Date: June 3, 2024

Subject: Response to April 17, 2024 Comments - Response to *Interim Long Term Monitoring Plan for Groundwater and Surface Water, Tyco FTC PFAS, 2700 Industrial Parkway South, Marinette, WI, BRRTS #02-38-580694*

WDNR Comments and Tyco Responses

**FTC (NON-GETS) PLUME AND BOUNDARY
ZONE WELL NETWORK**

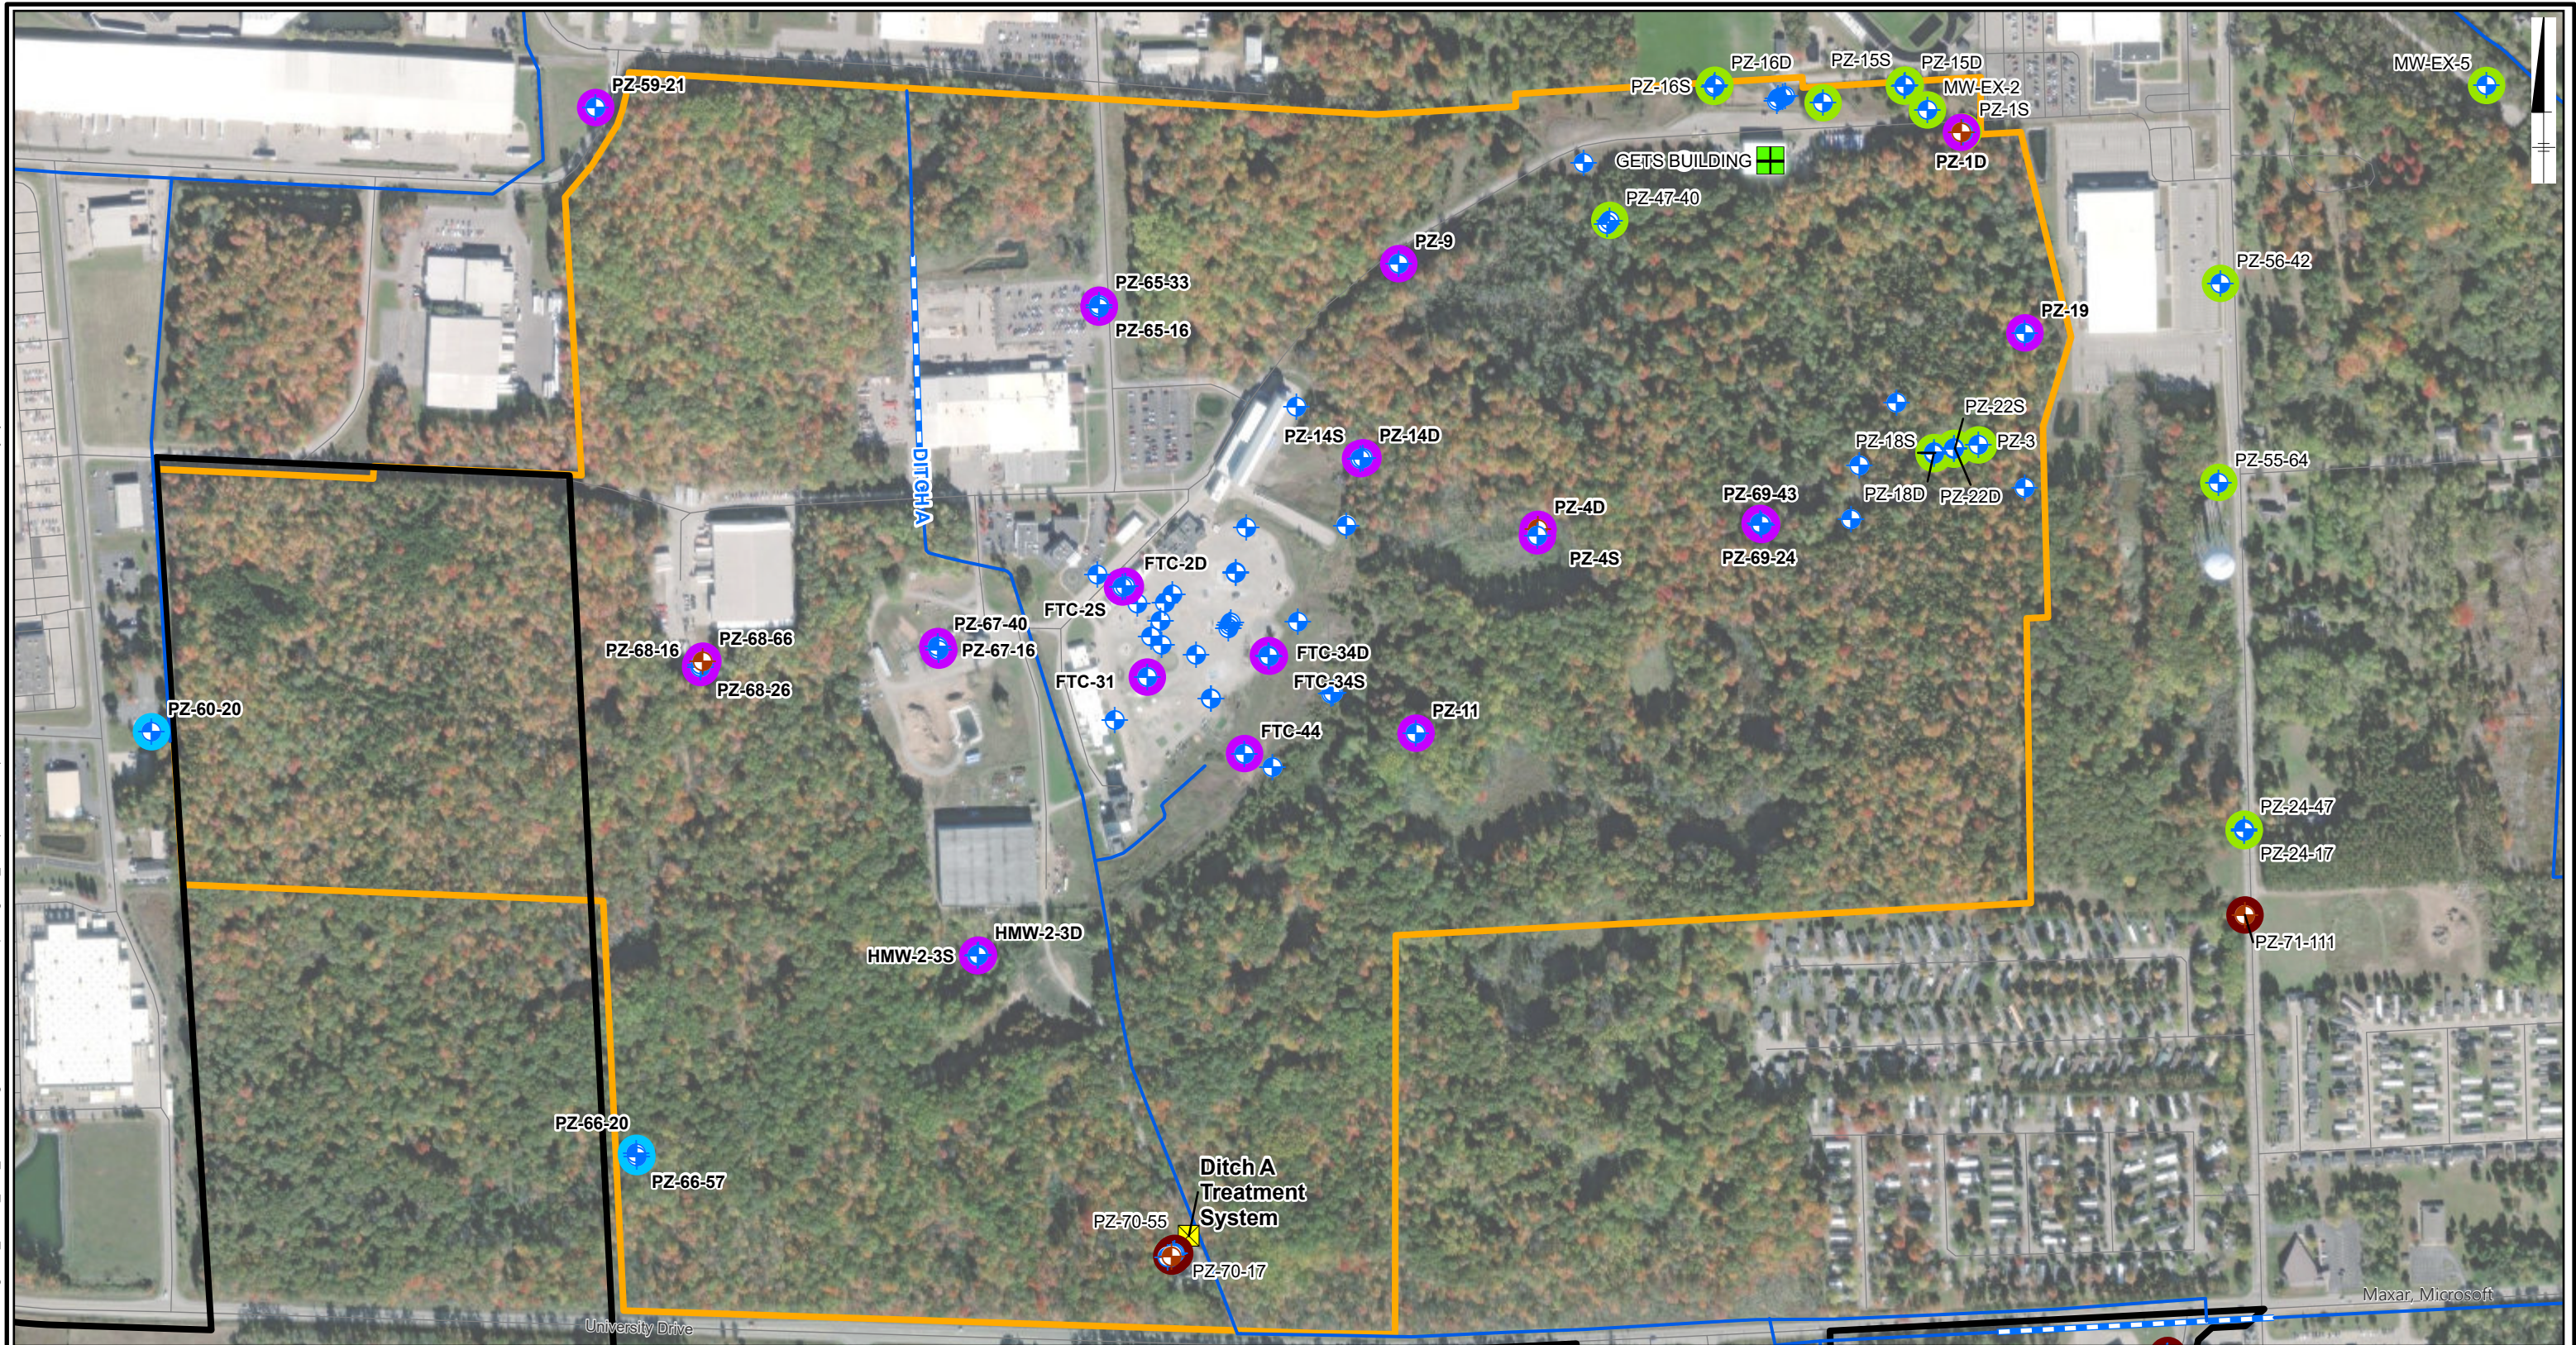
The DNR recommended including two additional existing bedrock monitoring wells (PZ-64-67 and MW003D) and two new monitoring wells (locations “m” and “n”) in the Interim LTM Plan. Of these four locations, MW003D will be included in the Interim LTM Plan as a replacement location for MW118D-R. Tables 1 and 2 and Figures 2 and 4 of the Interim LTM Plan have been revised to reflect this change. The revised tables and figures are provided as enclosures with this response letter.

The DNR has recommended installation of monitoring wells at six locations identified as locations “o” through “t”. Tyco will install additional monitoring wells at all locations except location “q”, which is approximately where existing GETS monitoring location U10 (in Ditch B) is located. At GETS monitoring location U10, surface water PFAS concentrations continue to be monitored and streambed groundwater has been monitored in the past. In consideration of these data, along with data from surrounding NR-141 compliant monitoring wells, an additional well at location “q” is not necessary to confirm plume stability.

Tables 1 and 2 and Figures 2 through 5 of the Interim LTM Plan (enclosed) have been revised to be inclusive of the additional monitoring well installations. Monitoring wells will be installed in accordance with the procedures and methods described in the February 2022 Additional Site Investigation Work Plan and the March 2024 Quality Assurance Project Plan. This work is expected to be completed in Fall 2024; however, the schedule will be dependent upon obtaining access to locations and driller availability.

ARCADIS | **FIGURE 4**

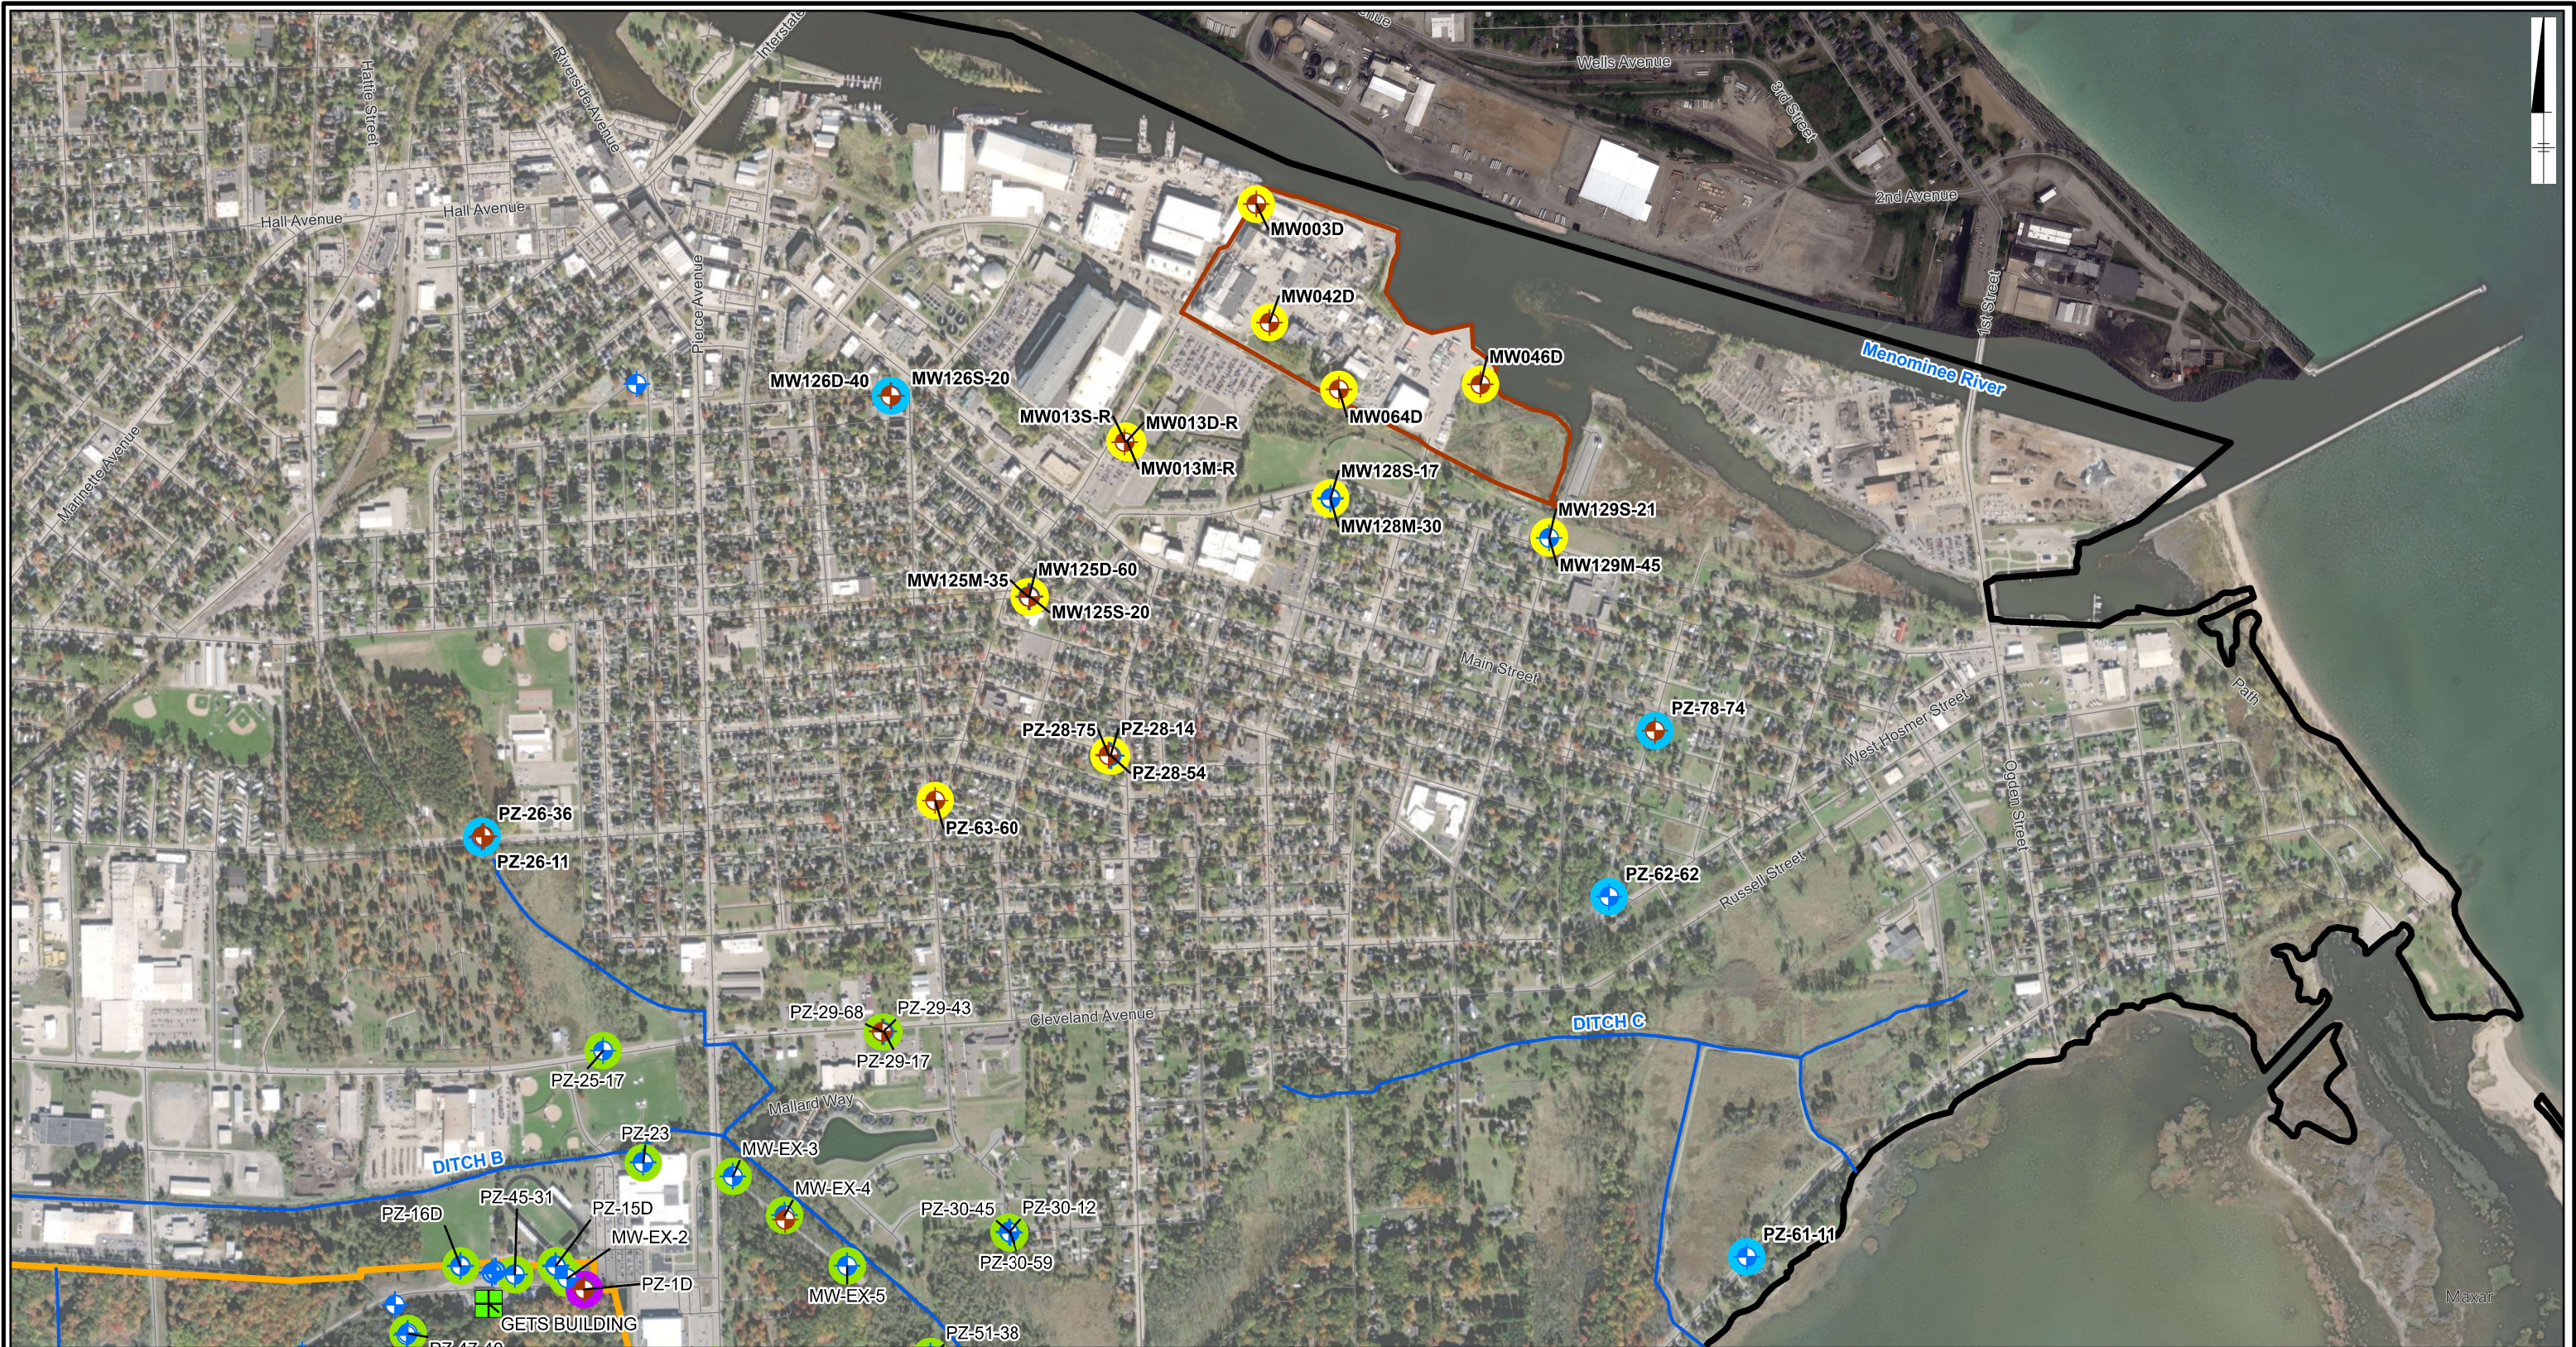
The DNR recommended including PZ-64-67 in the monitoring program; however, this well is expected to be converted to a groundwater extraction well associated with the GETS. Additional information related to the implementation of this well conversion was recently provided in the June 2024 GETS Short Term Monitoring Report #3 as Appendix A.

No additional bedrock monitoring well are currently planned at location “m”, which was recommended by DNR to monitor “concentration and stability at the FTC property boundary”. Approximately mid-way between location “m” and existing bedrock well PZ-4D, an attempt was previously made to install a bedrock monitoring well (i.e., as part of the PZ-69 well cluster) during the 2022 investigation work. As reported in the SISR, no water-bearing fractures were encountered at this location; therefore, a bedrock monitoring well could not be installed. PZ-4D, as well as all other bedrock monitoring wells within the footprint of the Site-related PFAS plume or within the Boundary Zone monitoring network, will be monitored regularly.

As indicated in the May 20, 2024 Response to March 21, 2024 Comments on the Stanton Street Site Investigation Status Report, no bedrock monitoring well will be installed near location “n”. Bedrock drilling
